Westinghouse  
Electric Corporation

NSD-NRC-96-4825  
DCP/NRC0608  
Docket No.: STN-52-003

SUBJECT: RESPONSE TO NRC QUESTIONS ON SEISMIC ANALYSIS

Figure 1 - Refined NI and Annex Building Models

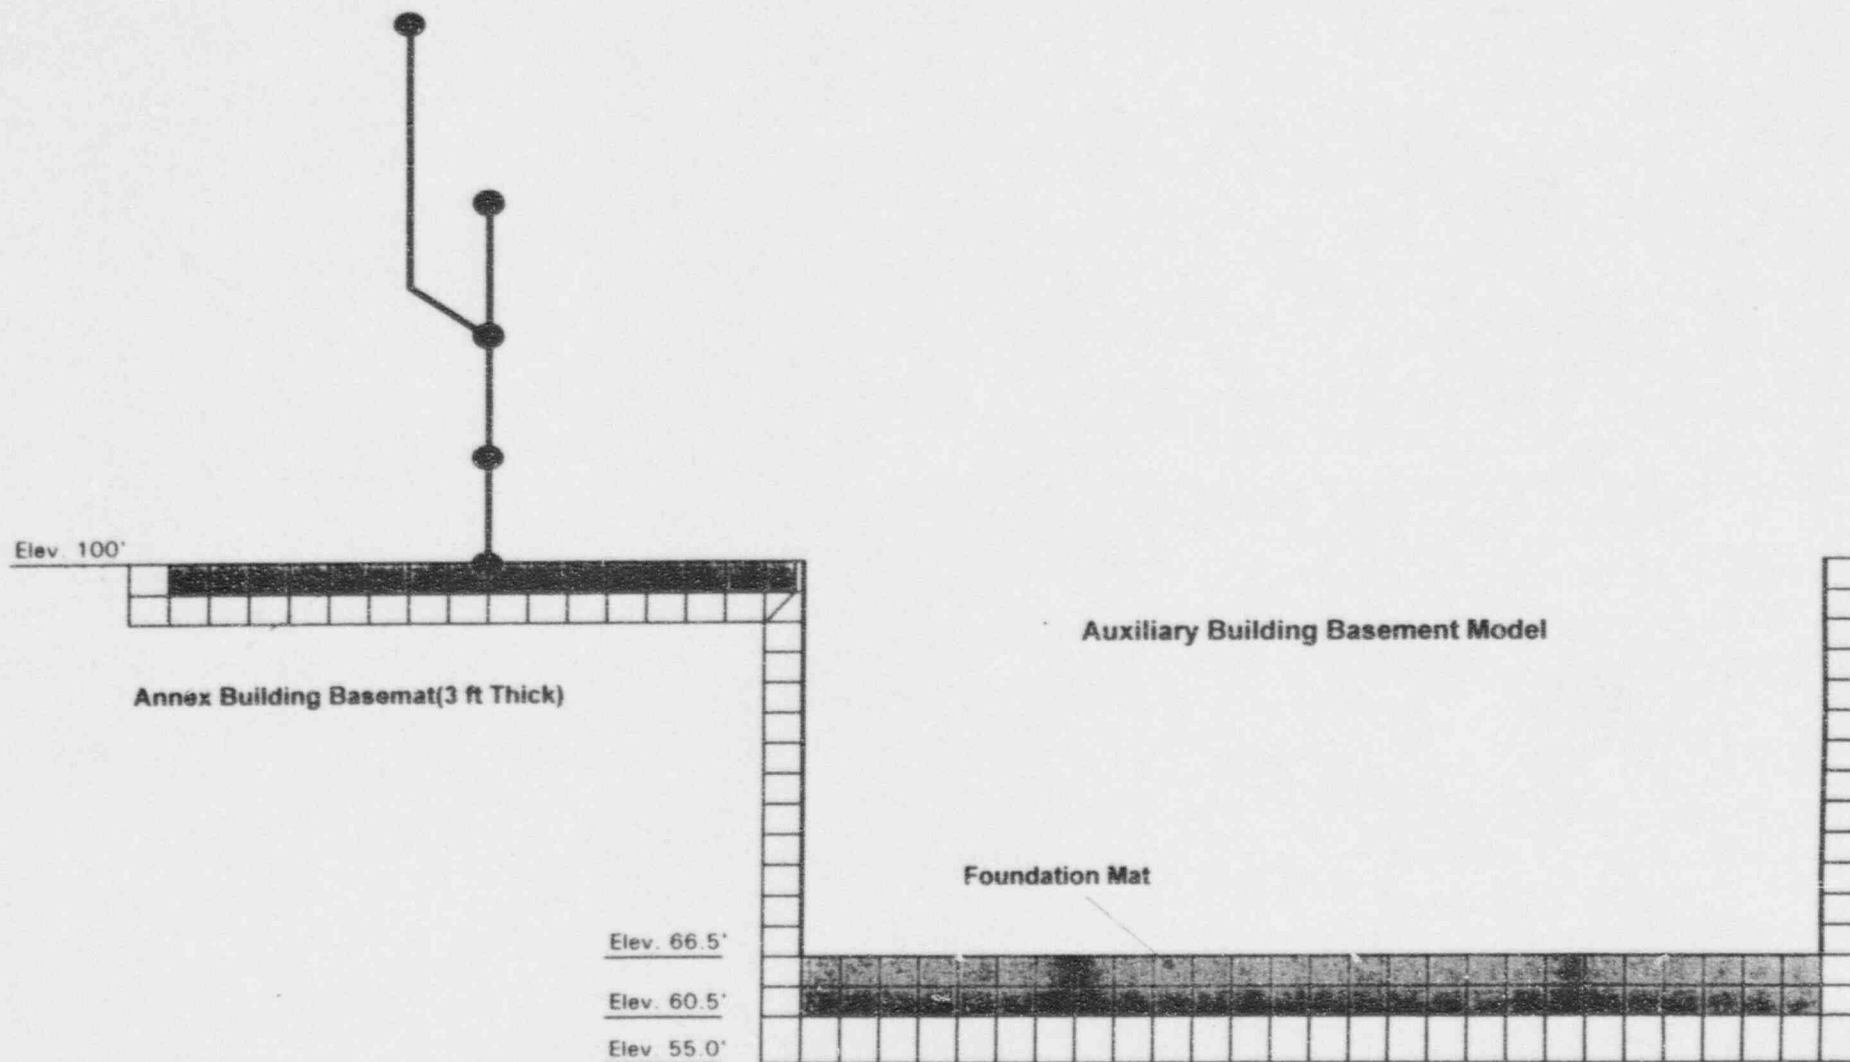
- a. Westinghouse needs to modify the 2-D SASSI structure-to-structure interaction analyses to determine the effects of adjacent non-seismic Category I buildings on the lateral pressure on NI external walls below grade due to horizontal seismic ground motions. The modified analysis will use models that will represent the material (or gap) between the buildings.

A refined two-dimensional SSI model of the NI and the Annex Buildings was prepared. The SSI model is shown in Figure 1. The dynamic properties of the Annex Building were represented by a stick lump mass model. The analysis was performed in the EW direction for the soft rock profile for both cases of the NI alone and the NI with the Annex Building. The results in terms of maximum lateral soil pressure on the East Wall (Annex Building side) and the West Wall were obtained and enveloped for the two cases analyzed. The results corresponding to the mid-height elevations of the soil elements of the previous SSI model are compared with the respective previous soft rock case results in Figures 2 and 3. As shown in these figures, the change in the maximum lateral soil pressure is insignificant. The increase near the basemat elevation (Figure 2) is considered insignificant for the design application.

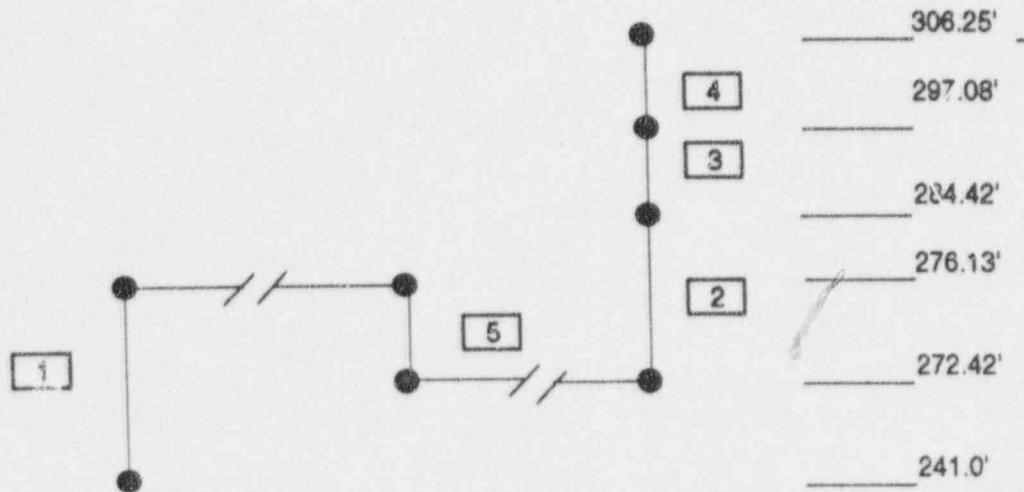
Compare the member forces of the shield building roof structure from the finite element model analysis with those to be calculated based on the stick model.

We have completed the comparison of seismic member forces in the shield building roof based on the 3D lumped mass stick model and the 3D finite element model (Item 1 in the referenced letter).

A table showing the comparison of the member forces and moments is attached. The forces and moments from the two models compare as follows:

All the forces and moments compare well between the two models. The 24% to 37% difference in the torque is acceptable, since the contribution from torque is not significant in the design of the shield building.

Figure 1

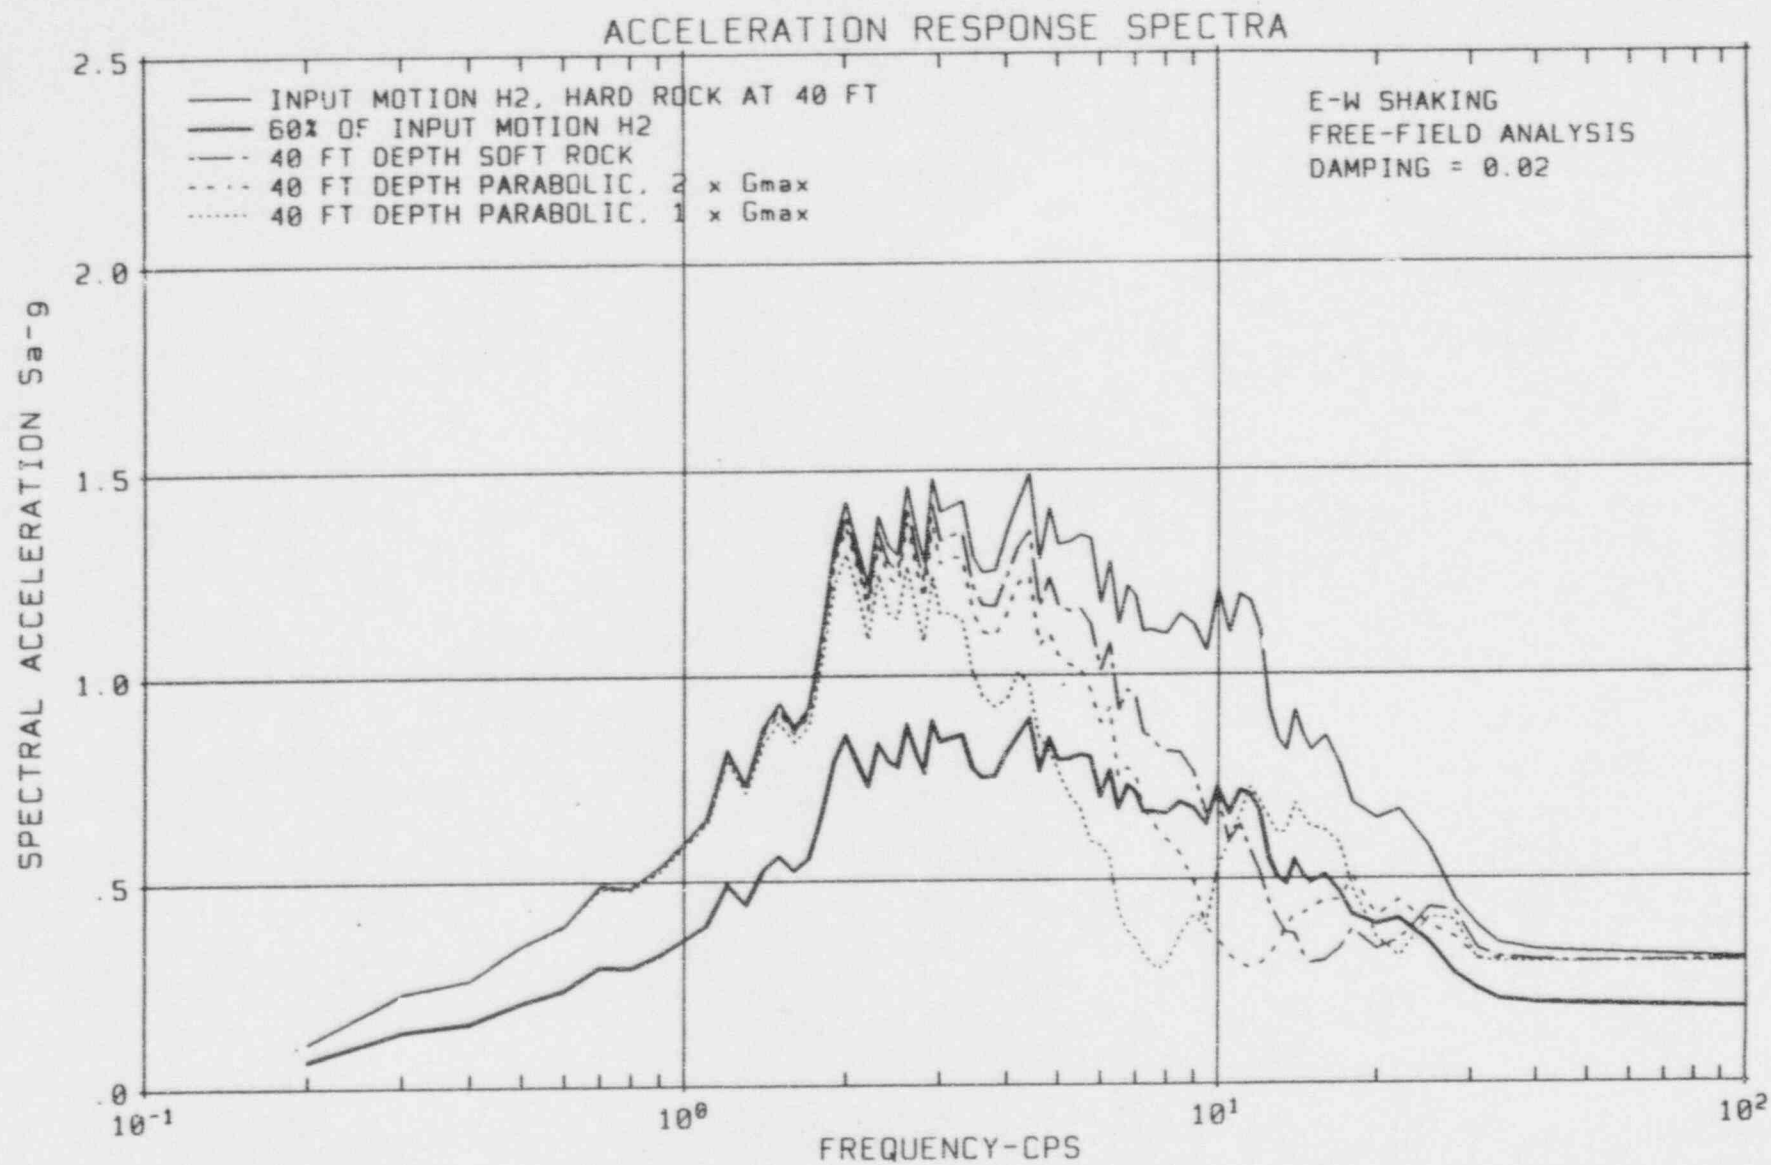
Westinghouse needs to verify the present SSI analysis results to ensure that the SSI and structural frequencies are such that the "dips" in the floor response spectra corresponding to individual soil column frequencies are enveloped by the final enveloping floor response spectra. Westinghouse has agreed to provide for each of the 4 soil categories:

- a. SSI and free-field (soil column) frequencies,
- b. In-structure spectra at the foundation level, and
- c. Free-field spectra at the foundation level.

- The acceleration response spectra at 2 percent damping from the free-field EW analyses at the depth of 40 ft corresponding to the basemat elevation. The results are shown in Figure 1.
- The acceleration response spectra at 2 percent damping corresponding to the basemat of the NI from the SSI EW analysis of the NI. The results are shown in Figure 2.
- A table of frequencies showing the soil column (upper 40 ft), the SSI, and the fixed base frequencies of the NI.

Based on the above results and since  $f_{\text{struct}} > f_{\text{SSI}}$ , the concern stated under Comment No. 8 does not apply.
